Bulletin: SCT1-008

Models: Super 8 50X and 150X

Subject: Recall instructions

Safety Recall Repair Instructions For KYMCO SUPER 8 50X and 150X Models

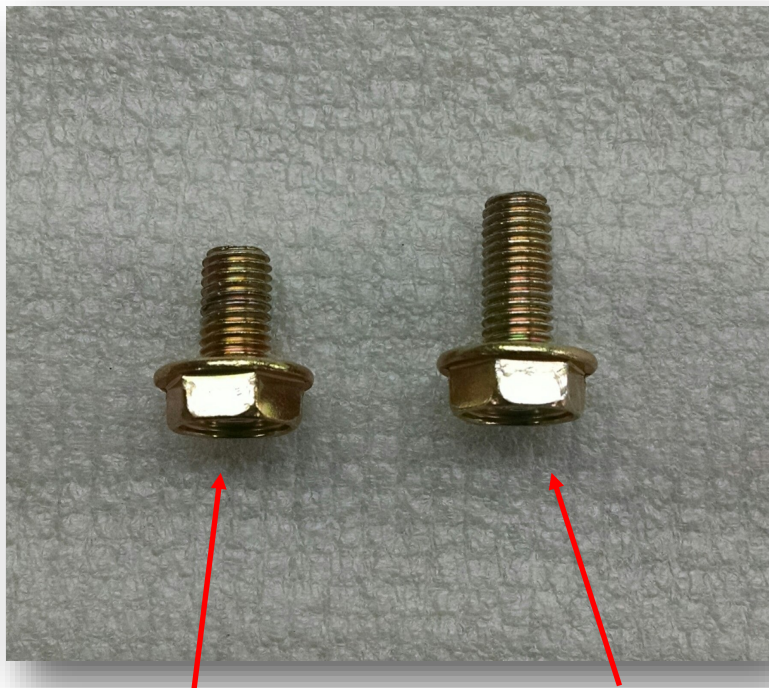
When the front suspension is fully compressed, the front brake hose may come into contact with the front tire, possibly wearing a hole in the front brake hose and loss of braking.

KYMCO USA will provide at no cost the hardware necessary to relocate the front brake hose clamp.

Original clamp

Replacement clamp

Original bolt

Replacement bolt

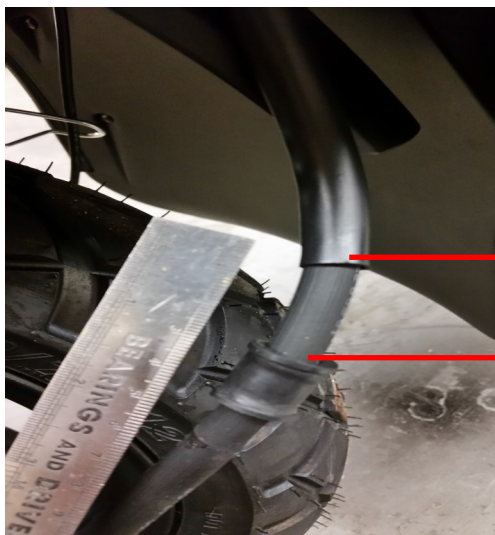
Using a 10mm socket, remove the two bolts holding the brake hose clamp and the reflector to the lower fork tube.

40mm

The grommet located on the existing brake hose must be relocated. Move the grommet 40mm higher than its current position. The grommet is glued to the brake hose, so you must use a small flat blade screw driver to break the grommet free from the hose. Use caution and do not damage the hose during this process.

The protective cover may need to be trimmed back in order to move the grommet 40mm. Using the provided super glue, reattach the grommet to the brake hose.

Using the supplied hardware, reattach the reflector and front brake hose to the lower fork

If the front brake hose shows ANY signs of wear, it should be replaced with part number 45126-KKD6-E00.
